Z600B

BRONZE GATE VALVE

BUREAU VERITAS Section02214J REVIEWED

Technical Comments Letter	30 Oct 2012	
Marine Division	O. Mai	l Ref. : DT2/12/03349
BV Reg. No : 02214J Project : HMAS SUCCESS		Hull No :
Yard(s):

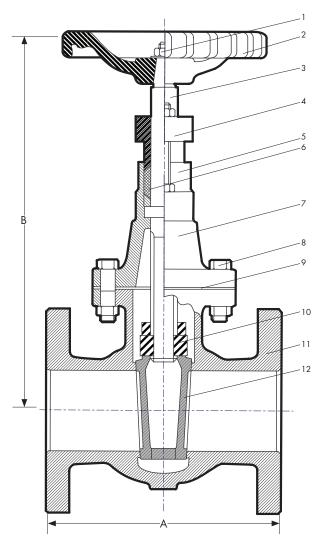
subject to the observations in red and only for parts concerning Classification.
All particulars not shown on this drawing and concerning Classification to be as per Rules.

Machinery - Comments on drawings						
Drawing number	Z600B Rev 0					
BRONZE GATE	VALVE					
ID : LPO695406	Inspection and testing at works for the valves :					
To be dealt with	Inspection and testing at works for the valves are to be carried out in accordance with BV Rules, Pt C, Ch 1, Sec 10-Table 38.					
ID : LPO695407	Since the material of the valves is bronze, ple :					
To be dealt with	Since the material of the valves is bronze, please note on the drawing that the valves are not allowed to be used as boiler blow-down valves connected to the shell plating. (Pt C, Ch 1, Sec 10-Table 5)
